238 WEST BROADWAY (COMPLETE APPLICATION)
DE415565 - ZONE C-3A

DEVELOPMENT PERMIT STAFF COMMITTEE MEMBERS

DEVELOPMENT PERMIT STAFF COMMITTEE RECOMMENDATION: APPROVE

A-2.03

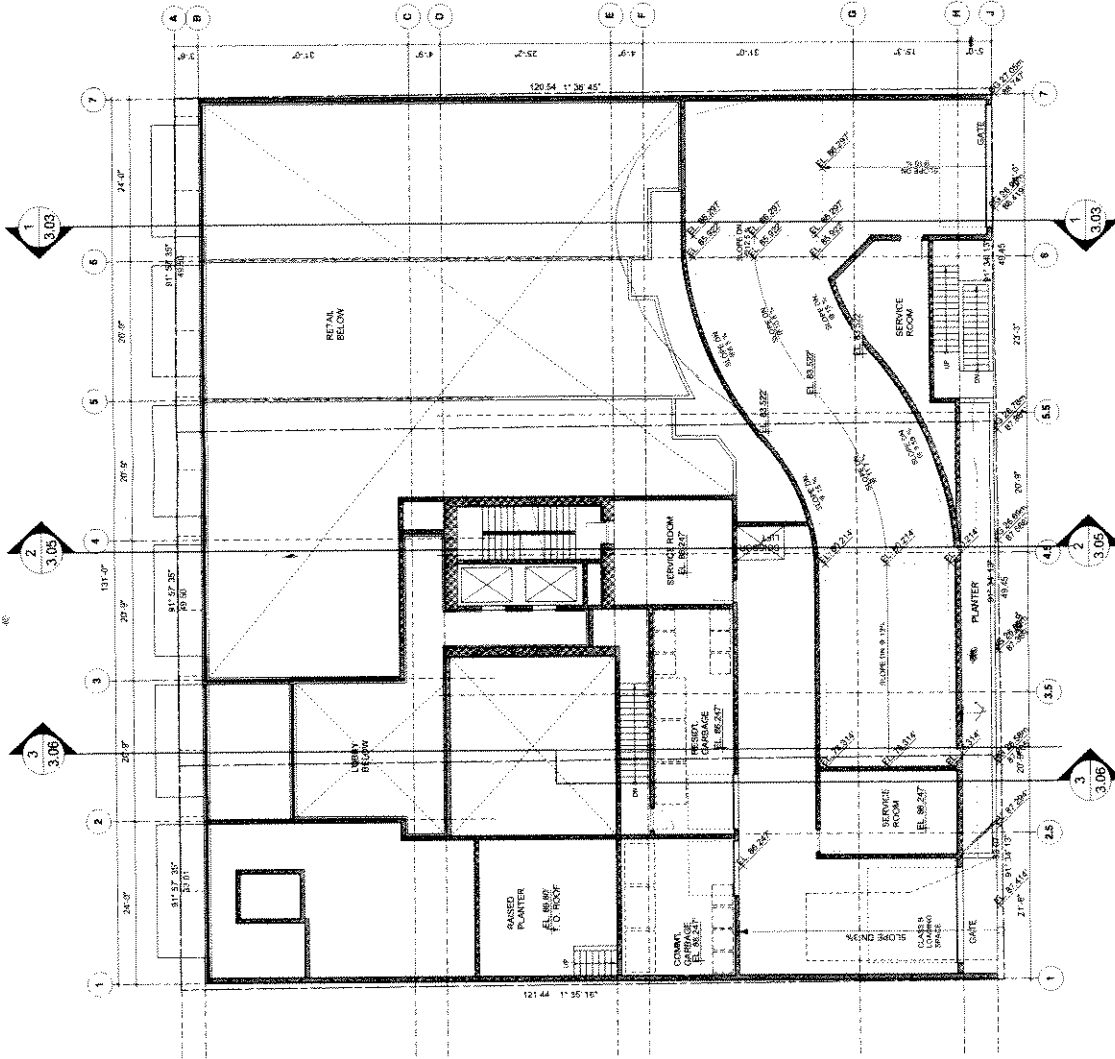
IV. East Elevation Section 1 drawing on Sheet No. A-3.03 and Intermediate Floor Plan on Sheet No. A-2.03 do not match at the underground parking entry;

A-3.05

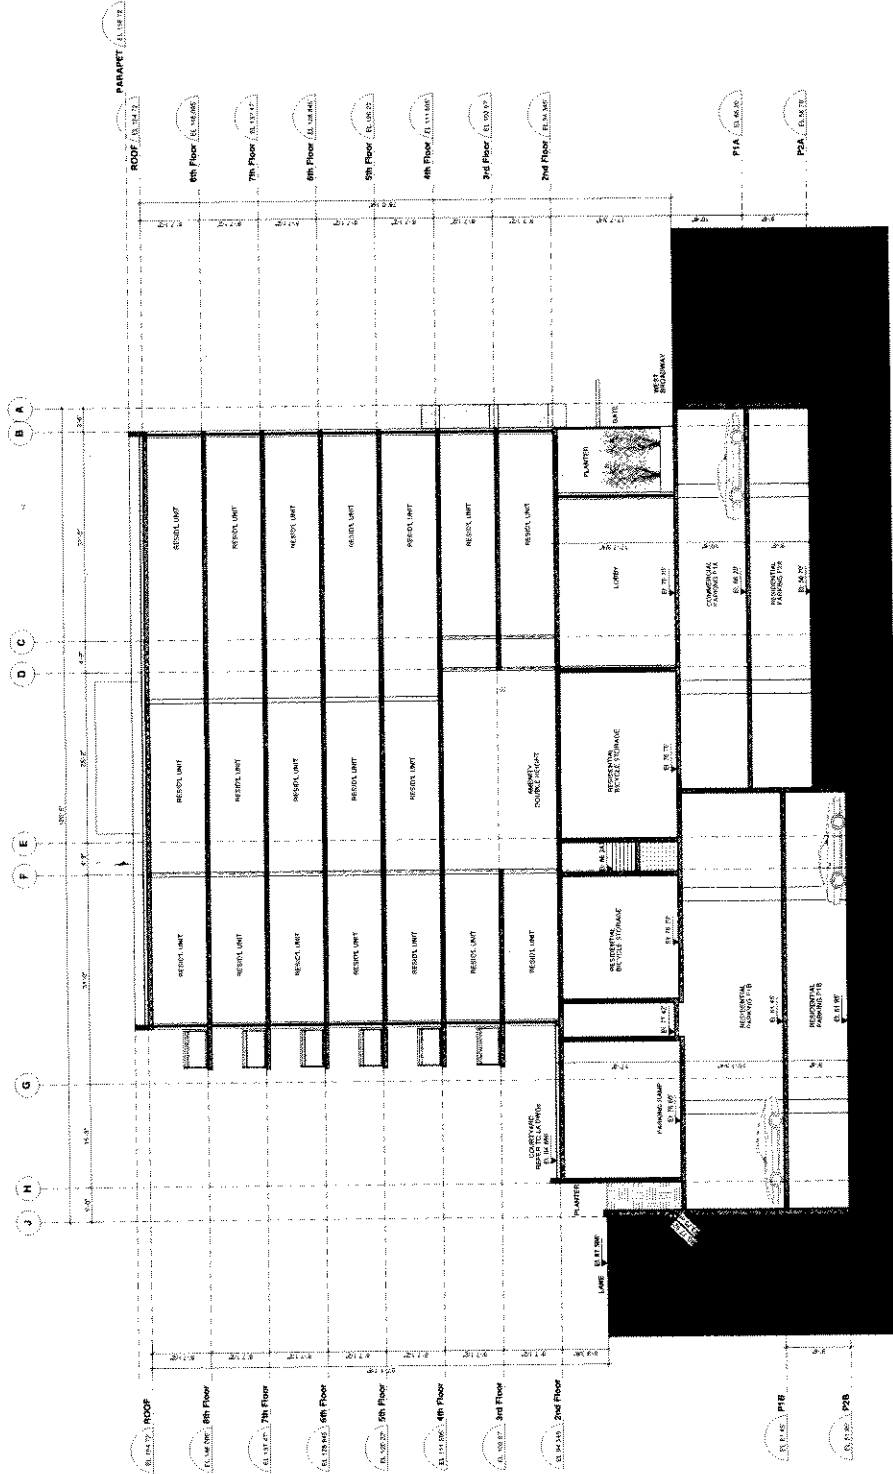
Note to Applicant: The floor levels shown on the ground floor plan and on Section 2 on Sheet No. A-3.05 do not match.

SHADOWS

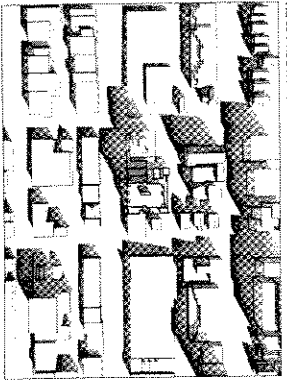
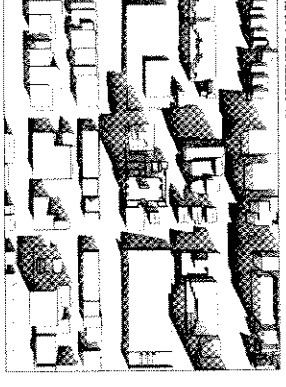
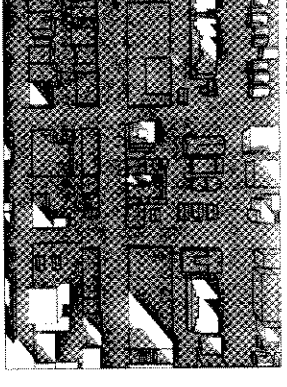
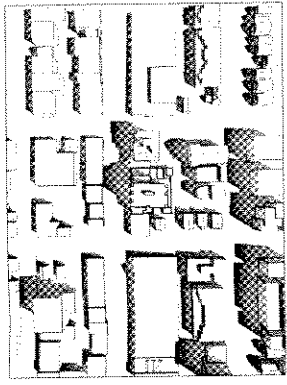
1.1 design development to improve sun access to the public realm, north sidewalk of Broadway, reducing shadowing by the proposed development;

Note to Applicant: This can be achieved by increasing the building setback by an additional 2 ½ ft. and by substituting glass canopies for the solid roof covers of the top floor balconies to achieve a shortened and more variegated shadow profile.

222, 230, 230
 W Broadway
 Landscape Plan
 Ground Floor

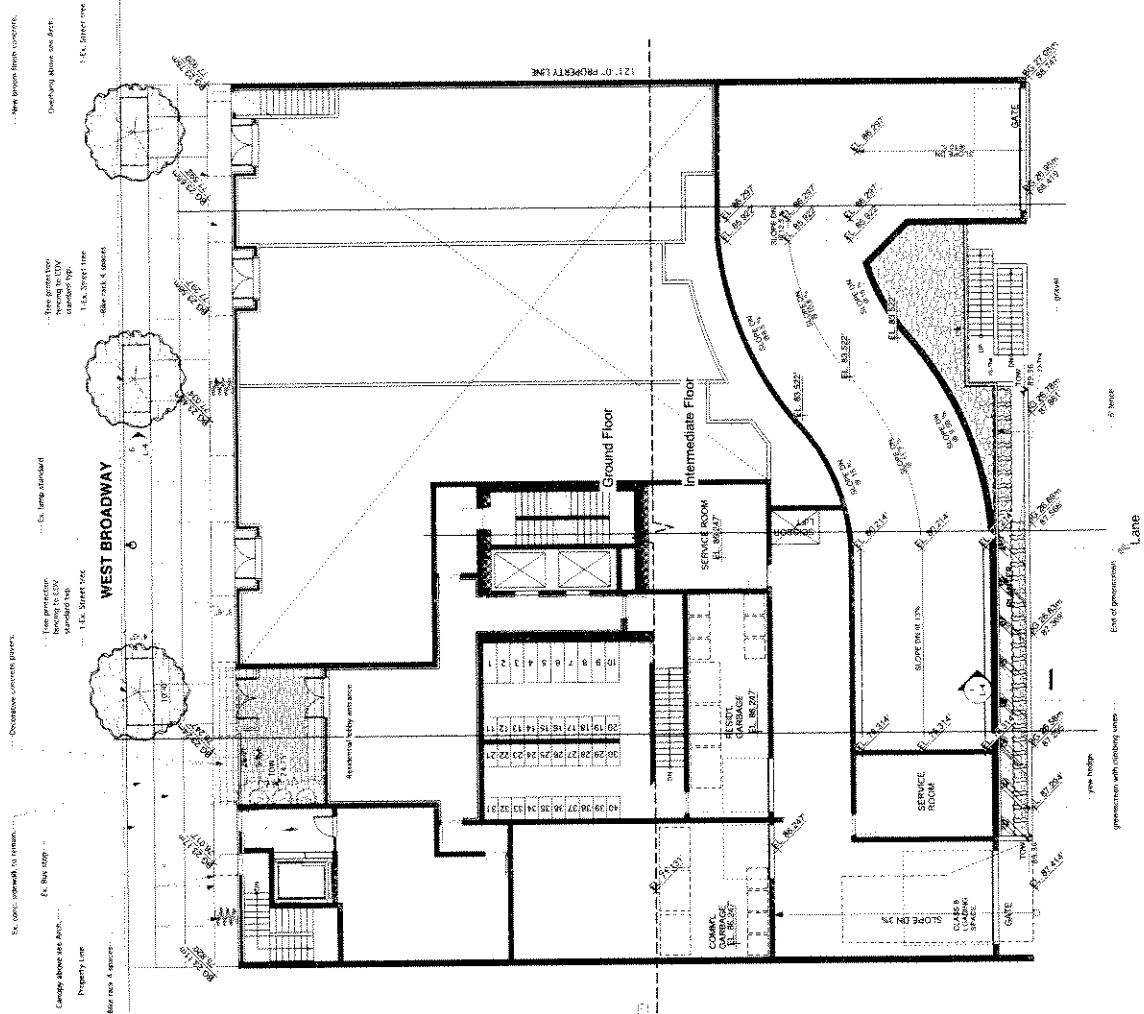
A.1.18 clarification of the type of planter proposed for the residential entrance planter, the names of plants for this planter, and a notation that this planter will be irrigated;

Note to Applicant: The plant symbols shown on the plan are not listed in the Plant List.

Drawings Title
Landscape
Sections and details

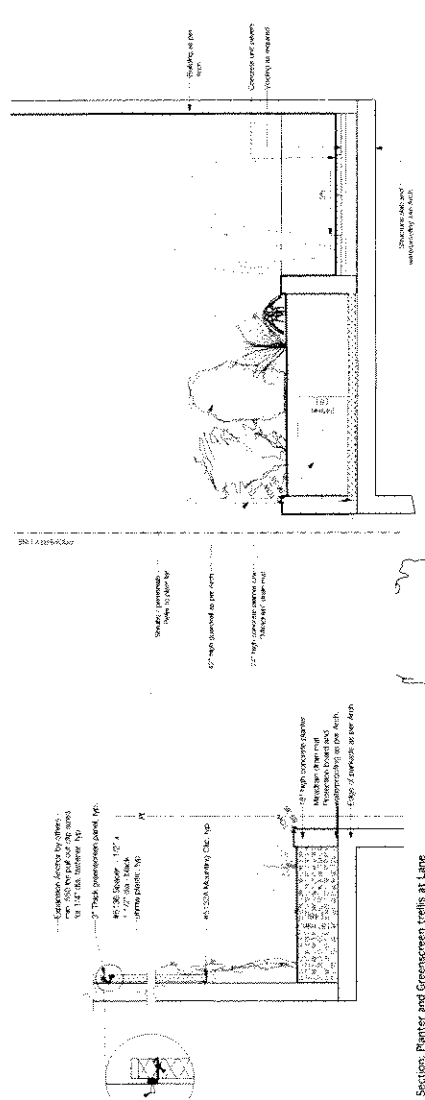
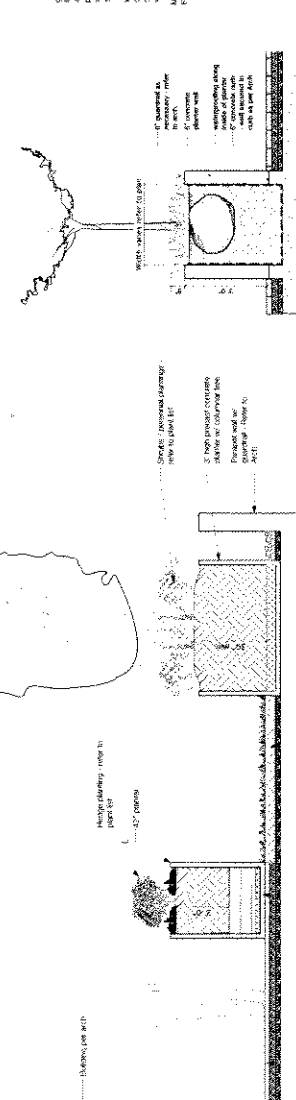
A.1.20 coordination of Landscape Section 1 of the lane edge planter and the Architectural Sections 2 and 3;

Note to Applicant: Landscape Section 1 shows an 18 inch deep planter and the Architectural Sections show an 8.0 ft. deep planter.
